ADDENDUM No. 4

Partial Rehabilitation of Runway 6-24

at the Manchester – Boston Regional Airport

Date: December 21, 2022

G-004

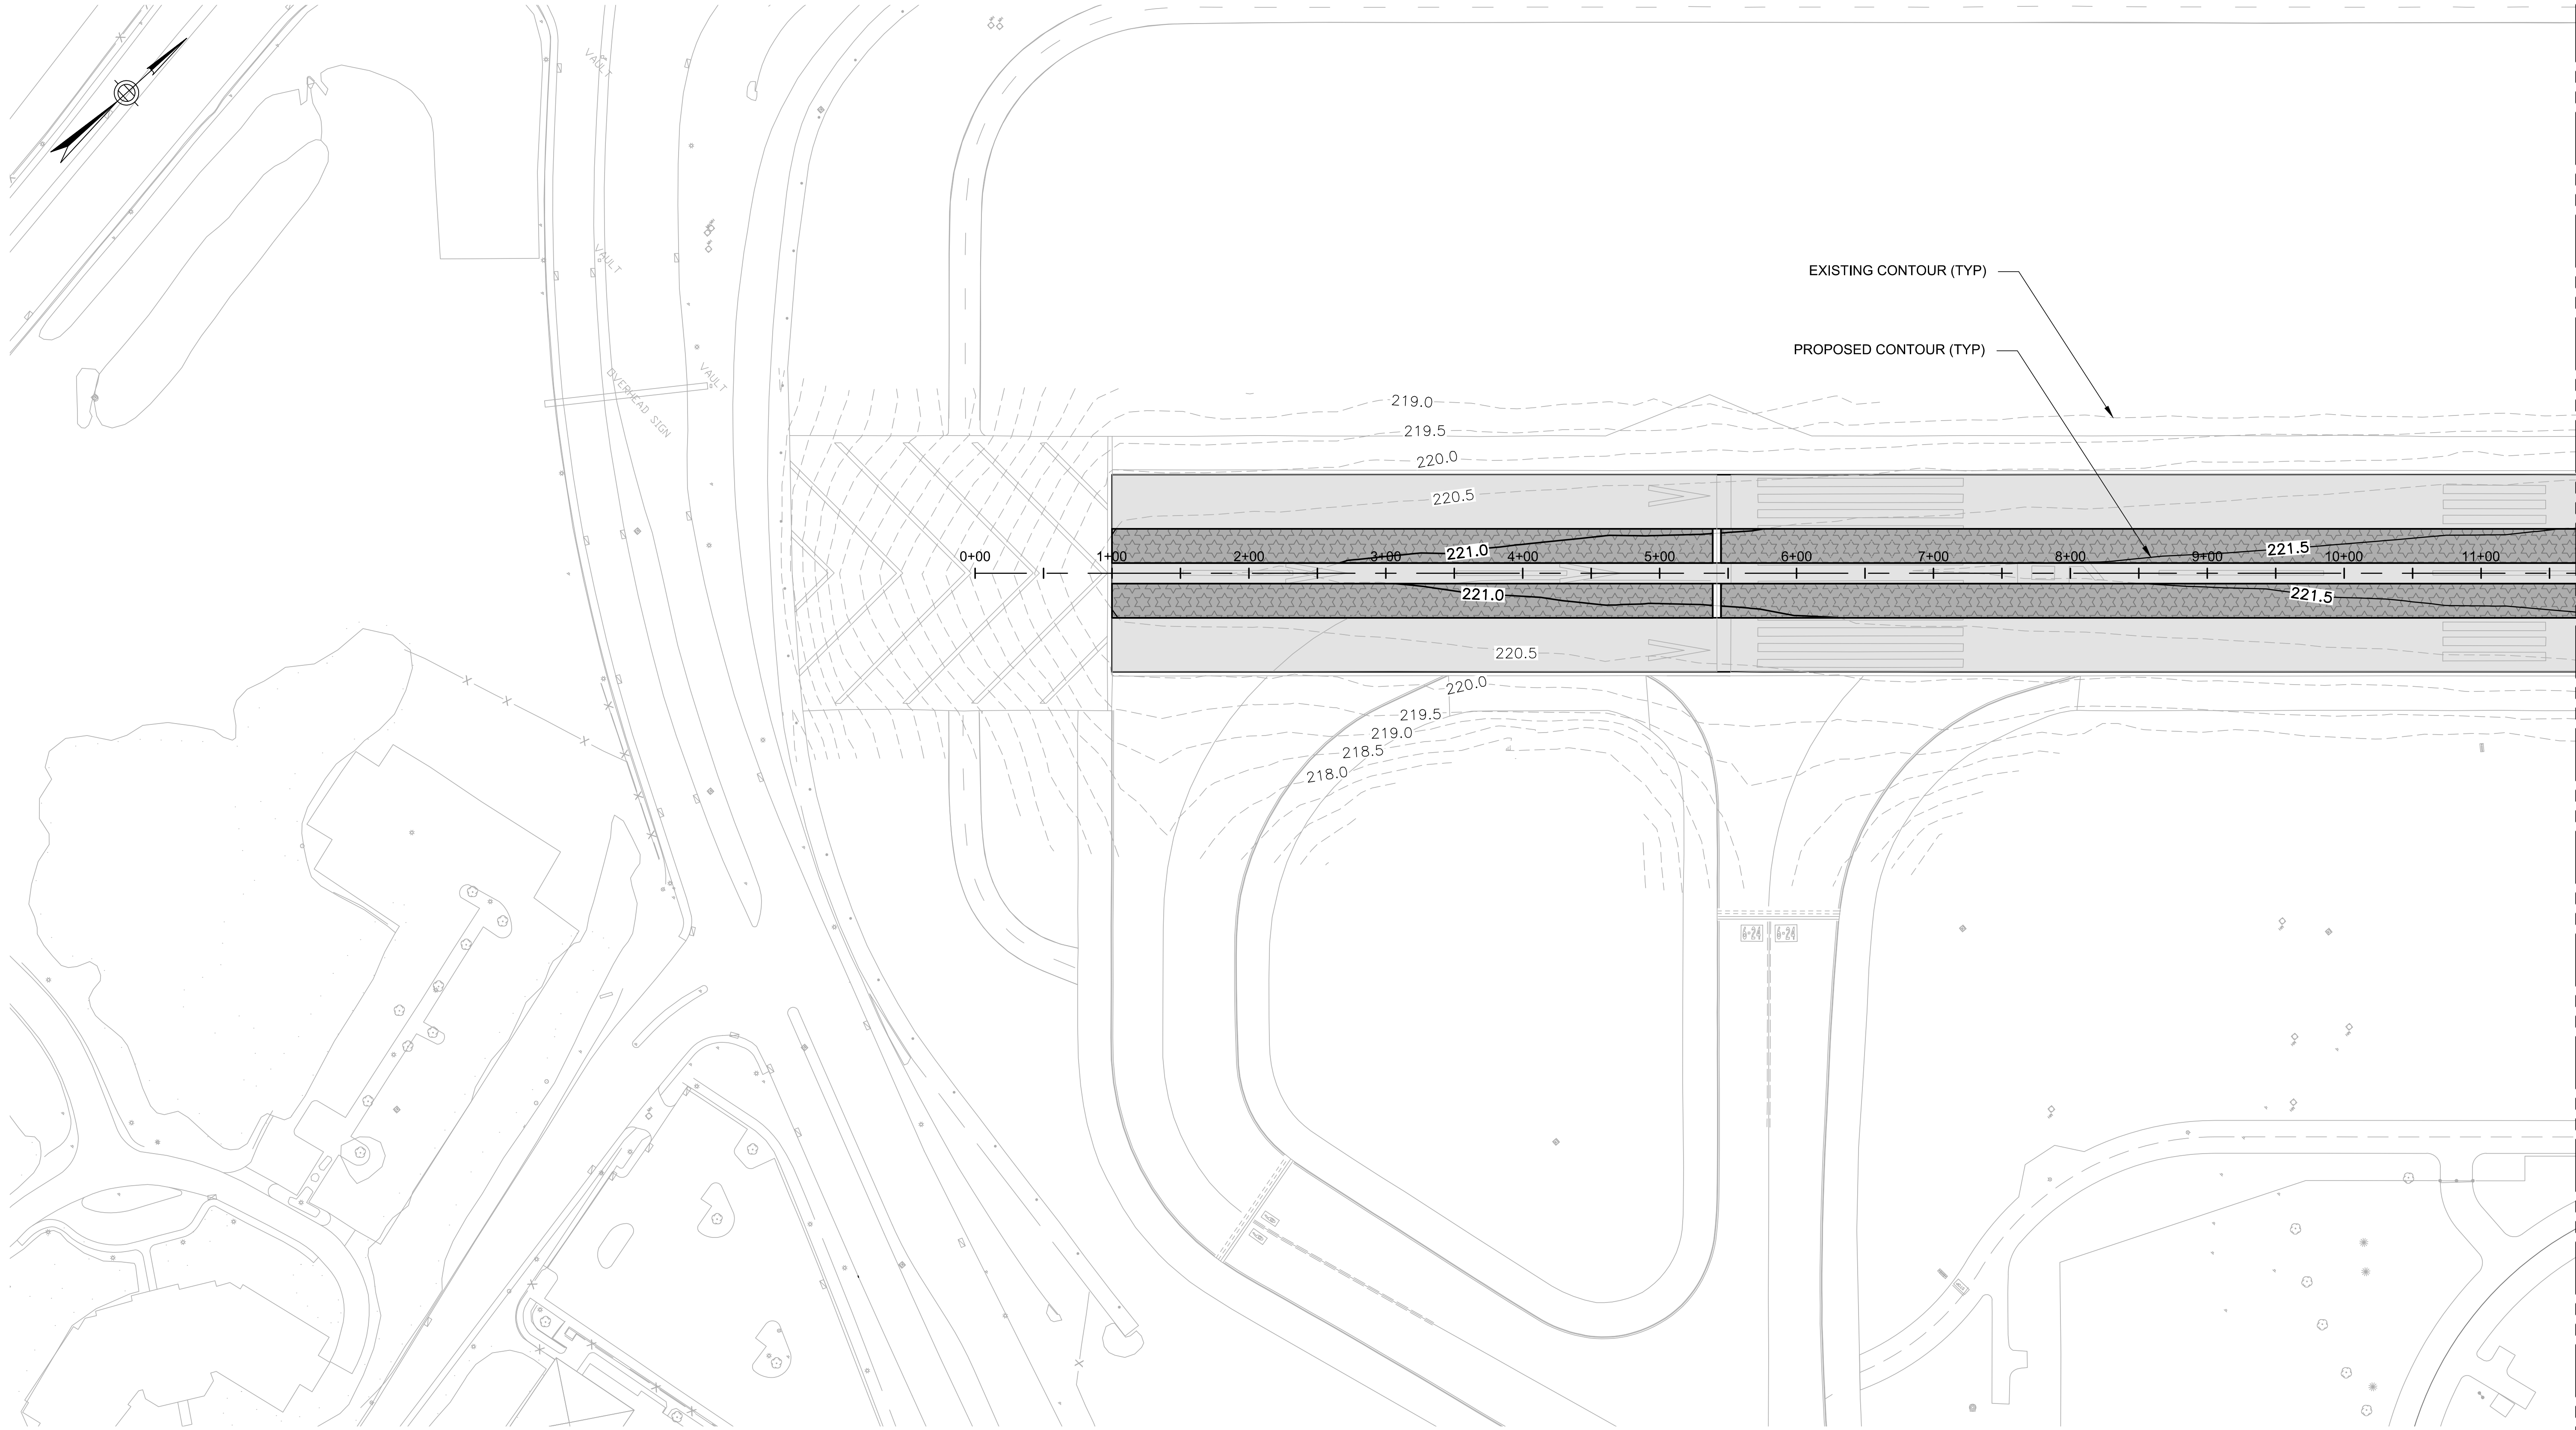
1. Answers to questions to date.
2. Updates to the Drawings:
 - a. G-002 Index of Sheets. Added new drawings C-301 to -313.
 - b. G-004 General Plan. Added survey control points and Taxiway H/J alignment.
 - c. C-201 to -204 and C-401. Remove notes regarding survey information to be issued via addendum.
 - d. C-301 to -313 (new drawings). Grading plans, profiles, and cross sections to provide additional information on existing pavement grades. The intent of the project is to match existing runway and taxiway grades.
